Sent: 14/11/2019 11:40:20 AM
Subject: Submission Notice - Alterations and Additions to a dwelling house- 2 Montague Place North Manly (DA2019/1165)
Attachments: Submission by Lori Brownbill.pdf;

DA2019/1165

Re: Objection Notice - Alterations and Additions to a dwelling house- 2 Montague Place North Manly

Example: Lean-to addition and lowered floor plates.

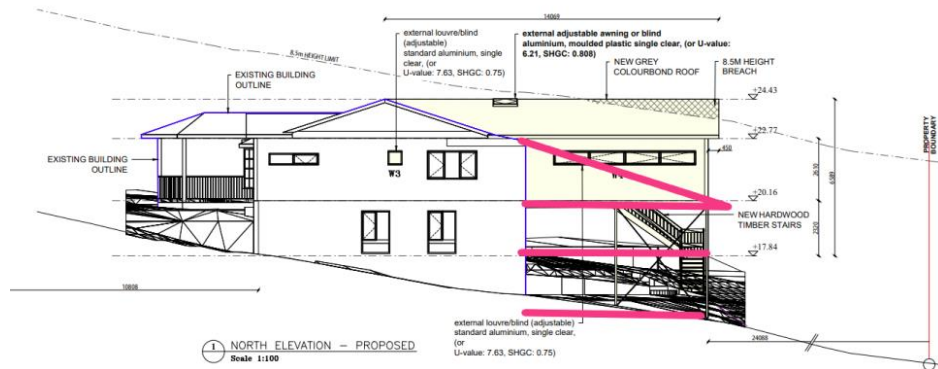
There is no reason why the topmost floor plate cannot be stepped or dropped to better reflect the topography of the existing ground levels.

There is no discussion in the Clause 4.6 Variation Statement that other designs or proposals had in fact been considered by the architect and how the design is site responsive and deals with the existing floor plates.

For example, there is no discussion why a lean-to addition was not an option and why the dwelling addition cannot be stepped to allow better access to the natural ground level as illustrated below.

Existing roofline not considered as an alternative and reduced lower floor plates.

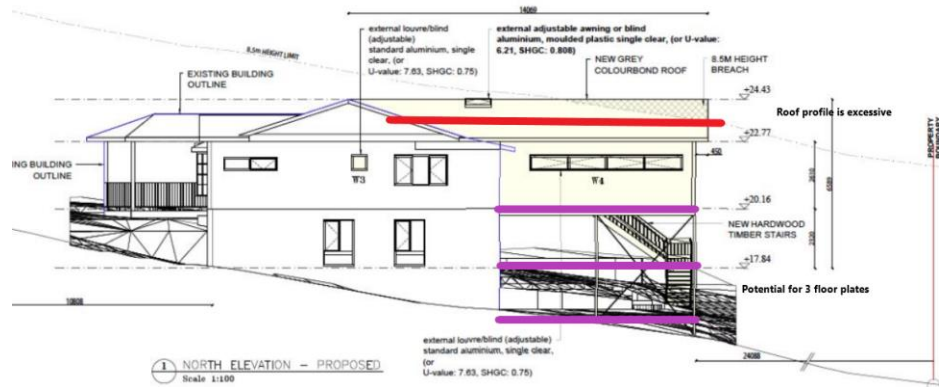
The rear appearance of the additions presents as a 3-storey dwelling built form and may allow the undercroft to be converted as additional floor space.

The topmost floor is excessively bulky in appearance and visually dominant.

The building mass does not step down the site as specified in the development control guide.

Approval of the current building design concept will permit the creation of 2 subfloors below the topmost floor plate and is a poor architectural outcome.

The design does not consider existing architectural rooflines from the front part of the dwelling as illustrated below and rather puts forward an unsympathetic design.
